Title: Advisory Committee on Reactor Safeguards
 Thermal-Hydraulic Phenomena Subcommittee
 Open Session

Date: Monday, September 19, 2016

Extended Flow Window (EFW) License Amendment Request for Monticello Nuclear Generating Plant (MNGP)

ACRS T-H Subcommittee

MELLLA+ Limitations

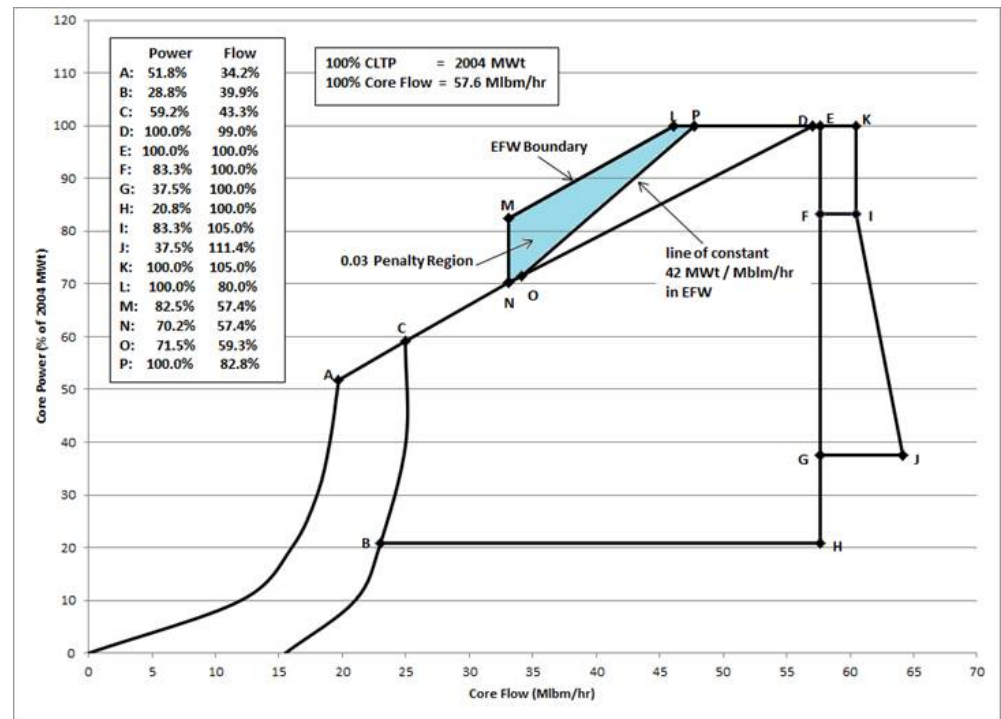
16 MS. MALANEY: So, the IMLTR requires
17 that extended operating domains are either limited
18 to 50 megawatts thermal per megapound per hour, or
19 provide additional information regarding
20 uncertainties.

16 CHAIRMAN CORRADINI: So, to say it
17 differently, it's not that you're asking to remove
18 the adder, but you're saying the adder will only be
19 effective in the blue region?

5 CHAIRMAN CORRADINI: How does that
6 limit operation in the blue region? That's what I
7 -- then, let me ask that question. How does that
8 limit operation? You've got to have a different
9 setpoint if I have the SLMCPR with the adder versus
10 without the adder?

- NEDC-33173 L&C 9.3 requires that EODs are either limited to 50 MWt/Mlb/hr or provide additional information regarding uncertainties. Met because the MNGP EOD is < 50 MWt/Mlb/hr
